FED. ROAD DIST. NO.	STATE	FED. AID PROJ. NO.	FISCAL YEAR	SHEET NO.	TOTAL SHEETS
HAWAII	HAW.	NH-H1-1(275)	2021	ADD. 29	65

TEMPORARY MOVABLE BARRIER PLAN

INTERSTATE ROUTE H-1 REHABILITATION
SALT LAKE BOULEVARD TO AIRPORT VIADUCT
FEDERAL-AID PROJECT NO. NH-H1-1(275)

ADD. 29

1 MOVABLE BARRIER POSITION FOR GRADE WORK DETAIL (INBOUND)

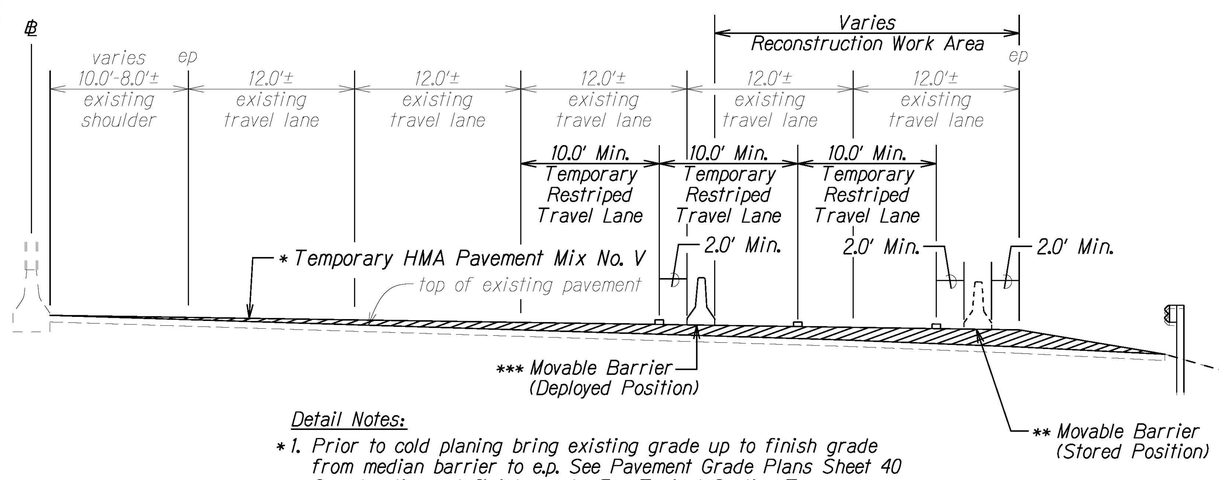
1 *** 3. Movable Barrier shall be installed once temporary HMA Pavement Mix No. V is placed to finish grade. Deploy movable barrier to shield active Reconstruction Work Area. Movable Barrier shall be moved to stored position during periods of time when lane closure is not allowed. Do not remove Movable Barrier from site until the new MGS guardrails within the Reconstruction Work Area are completed in place.

DATE	REVISION
1	11/10/21	Movable Barrier Position For Grade Work Details were swapped between sheets 29 and 30. Revised Detail Note 3.

1 MOVABLE BARRIER POSITION FOR GRADE WORK DETAIL (OUTBOUND)

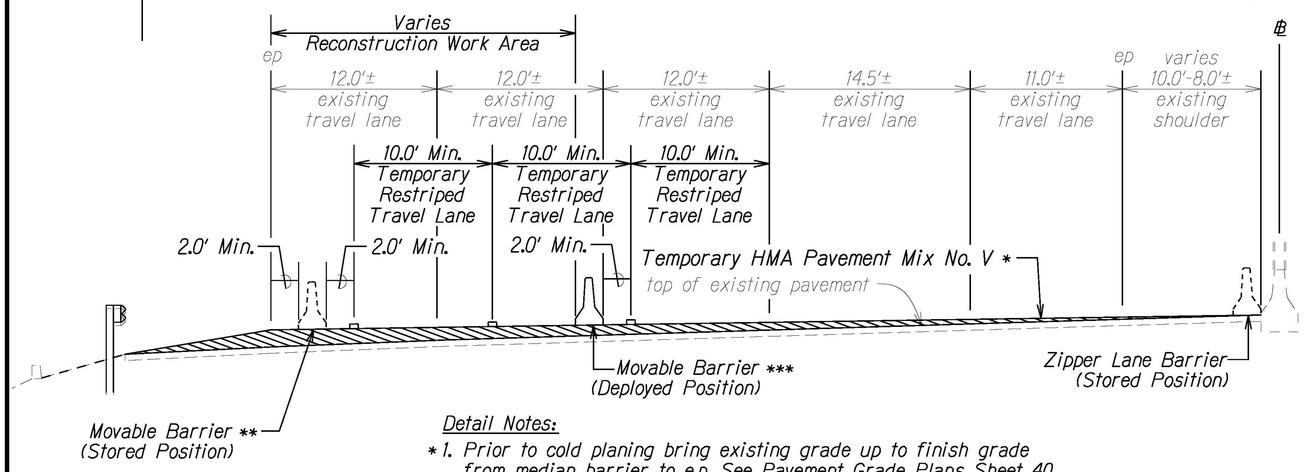
1 *** 3. Movable Barrier shall be installed once temporary HMA Pavement Mix No. V is placed to finish grade. Deploy movable barrier to shield active Reconstruction Work Area. Movable Barrier shall be moved to stored position during periods of time when lane closure is not allowed. Do not remove Movable Barrier from site until the new MGS guardrails within the Reconstruction Work Area are completed in place.

DATE	REVISION
1 11/10/21	Movable Barrier Position For Grade Work Details were swapped between sheets 29 and 30. Revised Detail Note 3.
